ADDENDUM No.: 2

Project Name and No.: MU Project #CP221943, BSA Project #14110010
University Physicians Medical Building – 3rd Floor Renovation
At the University of Missouri Columbia, MO

Date Issued: 28 April 2023

Description: REVISED DRAWINGS FOR DOCUMENT CLARIFICATION

G200

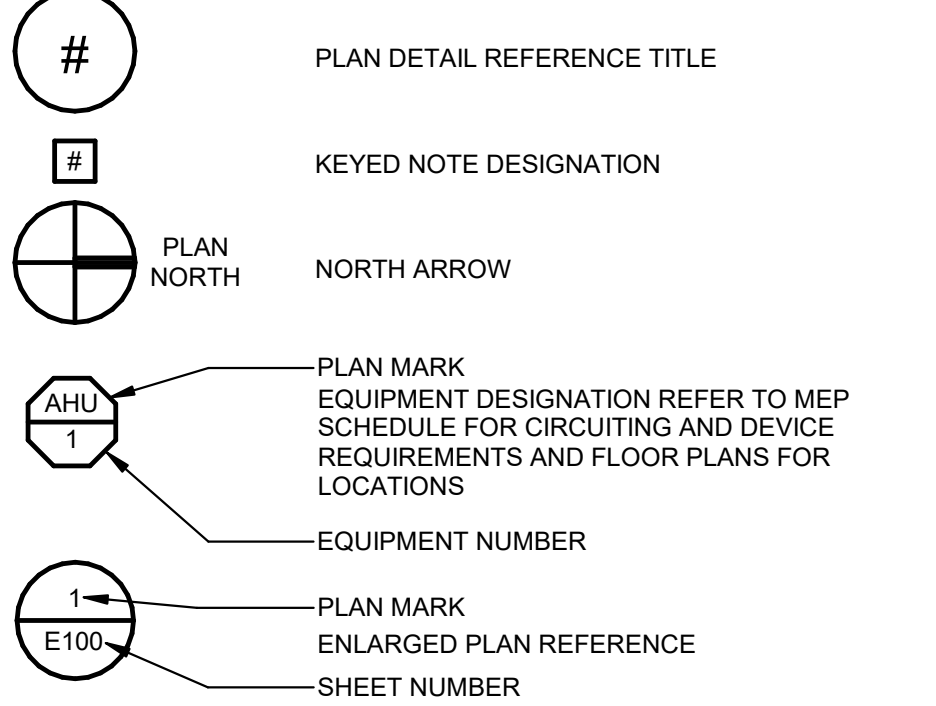
1. SHEET G200 – CODE SUMMARY & LIFE SAFETY PLAN

TITLE BLOCK:

- a. Revised issue date of ADDENDUM #1 to 04/25/2023.

NURSE CALL SYSTEMS

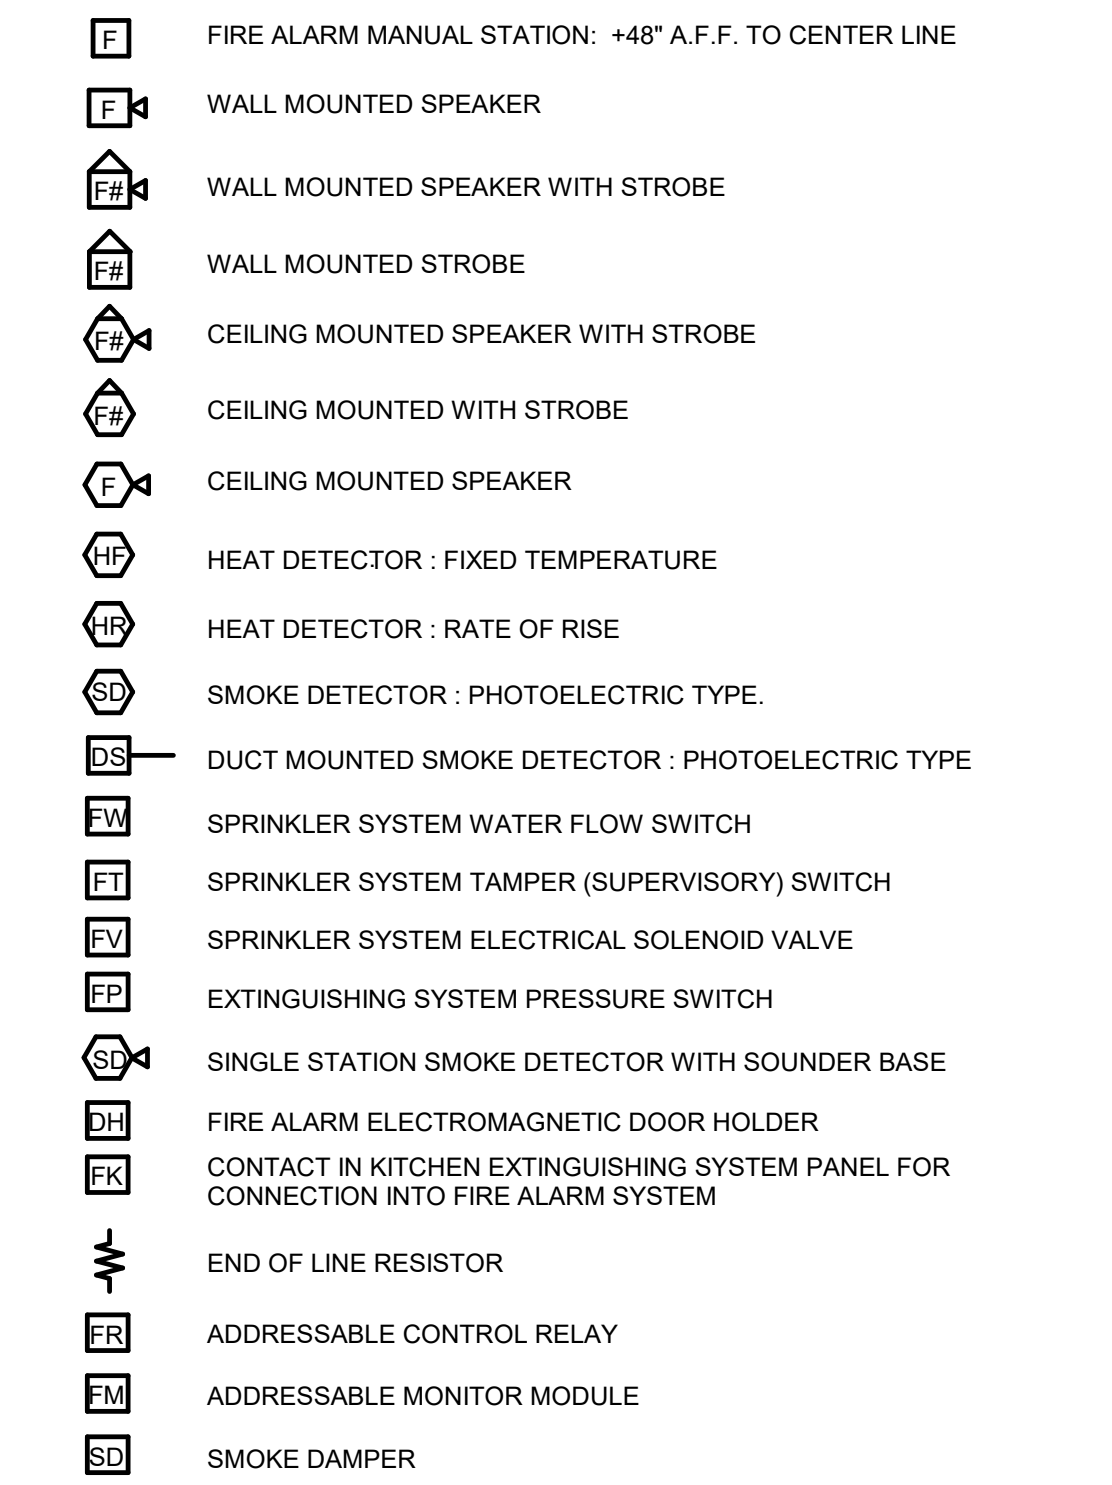
NURSE CALL SYSTEMS:

- a. Updated note to refer to the low voltage responsibility matrix as shown on E500 for scope responsibilities.

- REFER TO LOW VOLTAGE RESPONSIBILITY MATRIX ON SHEET E500 FOR MORE INFORMATION.
- EMERGENCY PULL CORD STATION: +48" A.F.F. AT TOILETS, +78" AT SHOWER STATIONS. CORD LENGTH SHALL EXTEND TO +6" A.F.F.
